CUSTOMER NOTIFICATION

SUD-FT-04-0105 (1/11)
April 19, 2004
Seiji Iigusa, Senior System Integrator Car Electronics Group 1st Solutions Division Solutions Operations Unit NEC Electronics Corporation

IE-703239-G1-EM1
(Control Code: A, B, C)

Operating Precautions

No.12 Bug in 16-bit timer M compare register

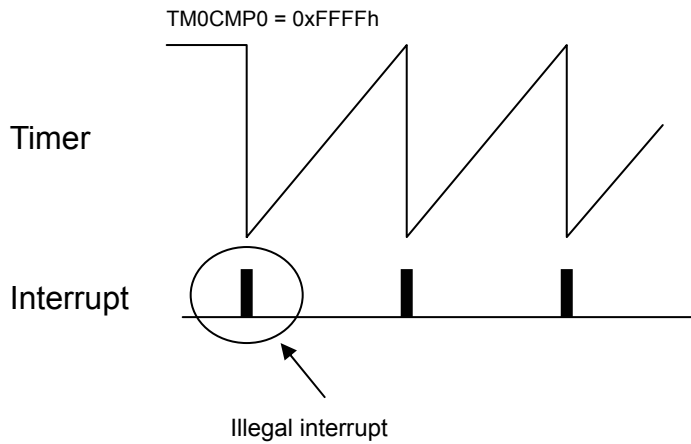
An illegal interrupt occurs after timer M activation when the compare register TM0CMP0 is set to FFFFH. See the figure below for details.

Do not set TM0CMP0 to FFFFH.
This bug has been corrected in control code C.
